SECOND/THIRD READINGS SUMMARY SHEET

CASE: C814-2023-0027 (311-315 South Congress PUD) DISTRICT: 9

ZONING CHANGE REVIEW SHEET

Re: Update 2 Comment Response: 311-315 South Congress PUD – Planned Unit Development (“PUD”) application for the property located at 311-315 South Congress Avenue in Austin, Travis County, Texas (the “Property”).

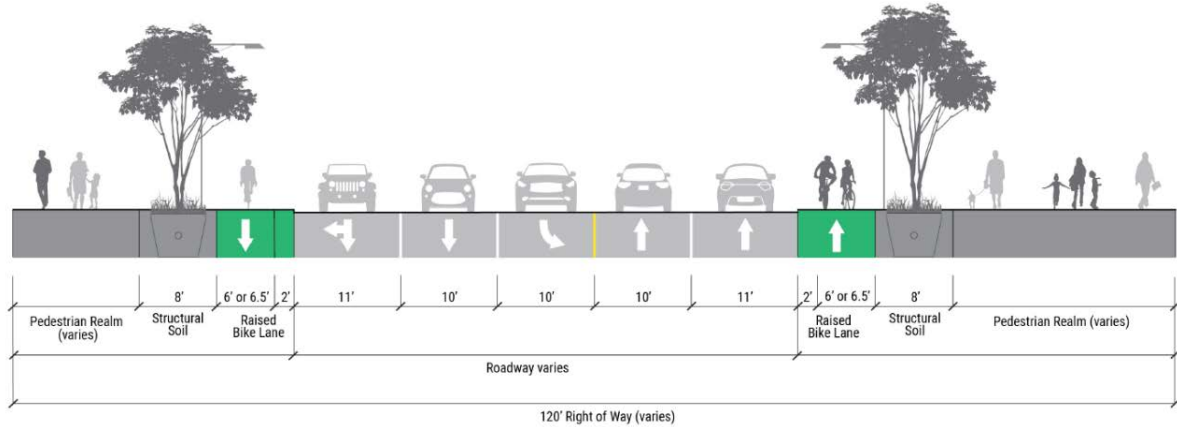
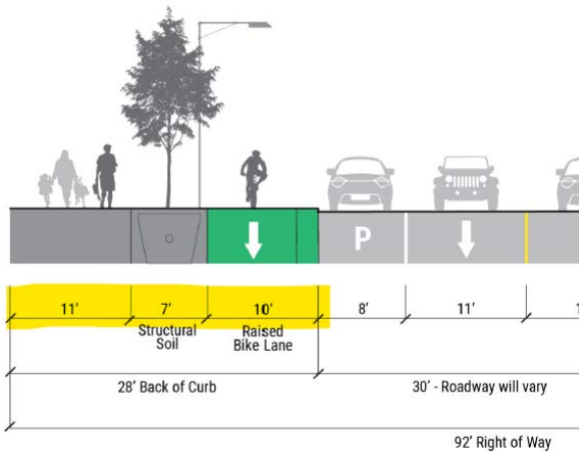
ATD 7. ATD does not recommend approval of this proposed language of Land Use Plan note #8 (noted above). To provide superiority for the streetscape, we request that the site adhere to the streetscape standards as depicted within the proposed in the South Central Waterfront Plan:

S. Congress: The South Central Waterfront plan calls for a 6’-6.5’ raised bike lane behind a 2’ buffer along the east frontage of S. Congress. The ASMP identifies protected bicycle facility along Congress frontage as well. In order to meet the superior results expected from PUDs, the cross sections should at least meet the baseline set by ASMP.

Barton Springs Road: The South-Central Waterfront plan calls for an 11’ pedestrian zone and 8’ planting zone, adjacent to an 8’ raised bike lane behind a 2’ buffer along the southwest frontage of the Barton Springs Road extension. In order to meet the superior results expected from PUDs, the site’s frontage along the Barton Springs extension should provide these streetscape elements as depicted below:

U1: Comment cleared.

V:\113874-0001\CADD\CADD\EXHIBIT\113874-0001-1-Reclaimed Water-EXH.dwg modified by pdelaha on Aug 3, 2024 3:50 PM

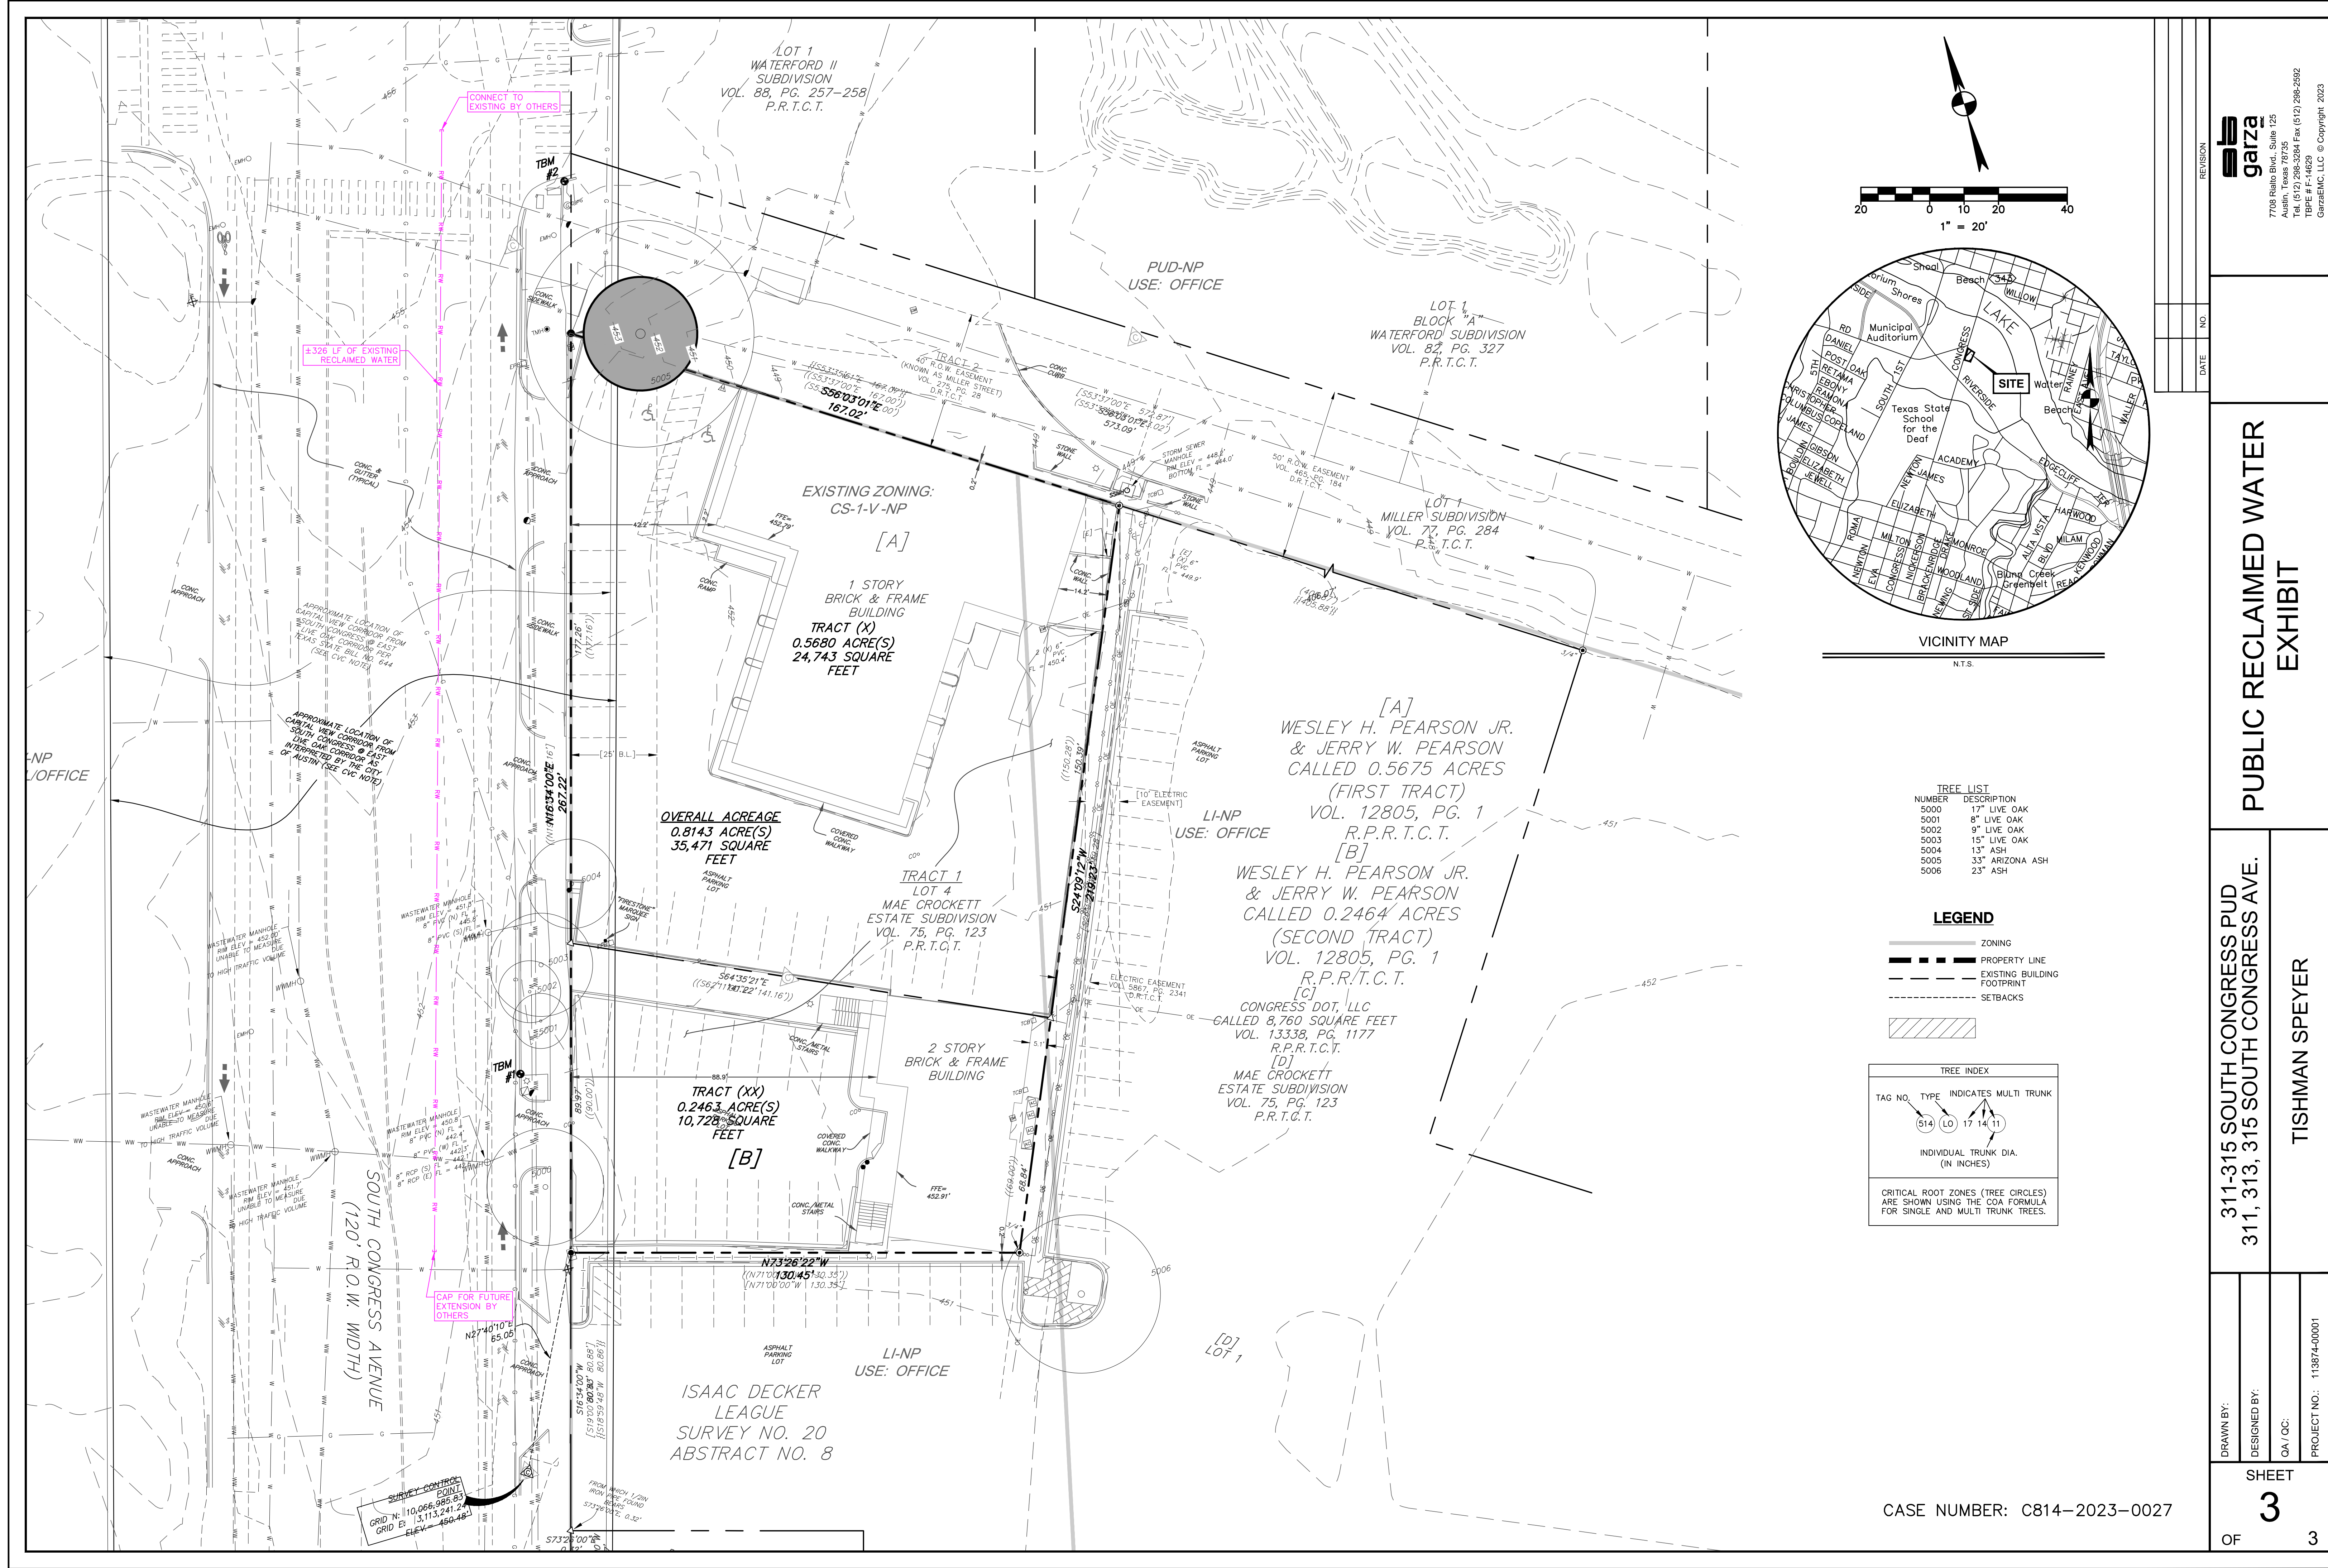
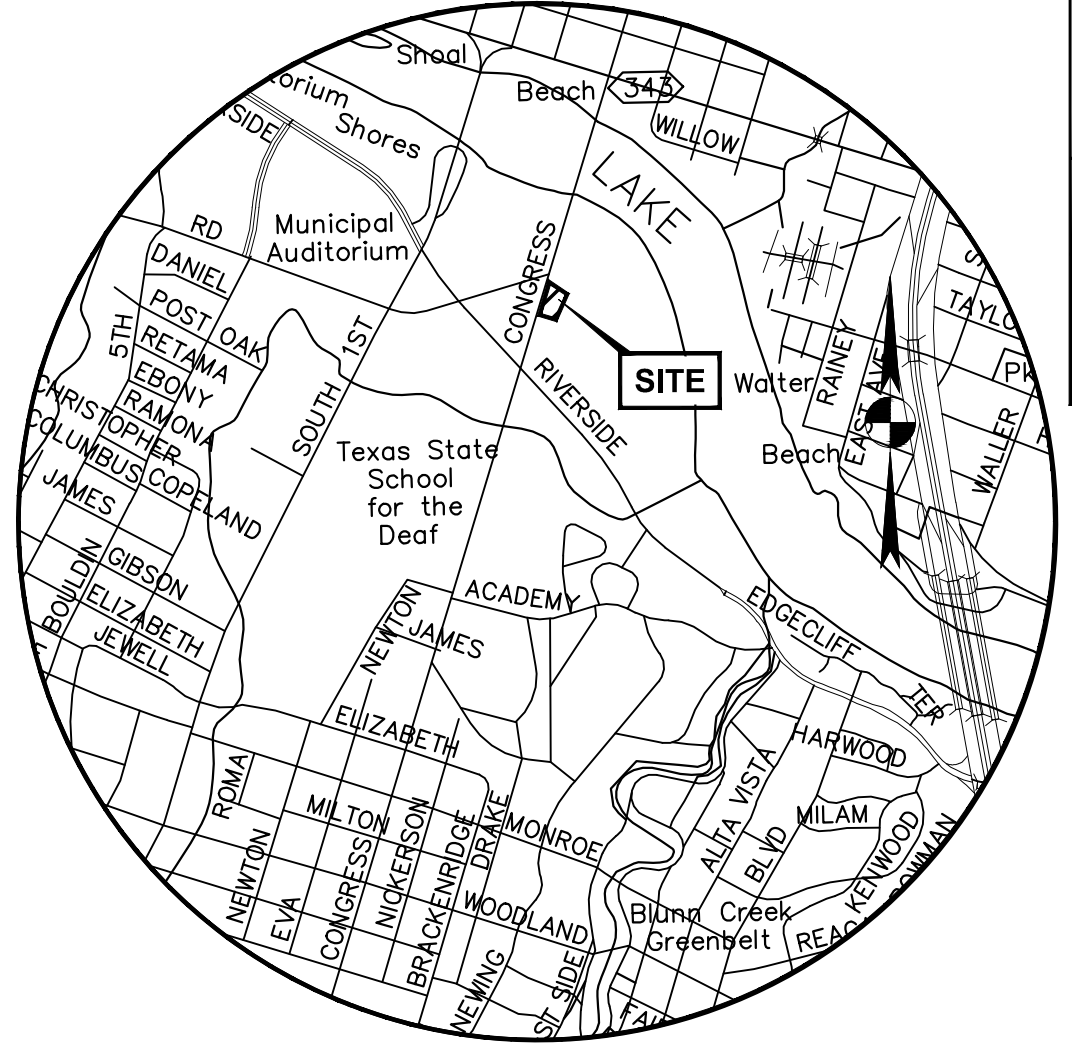
AW1. 311-315 South Congress shall build an off-site reclaimed main from the nearest, existing or planned, point of intersection of the reclaimed system to the development.

- **Update 2 Response:** A site map exhibit demonstrating the proposed location of the reclaimed water main extension along the frontage of the Property is included with this Update package.
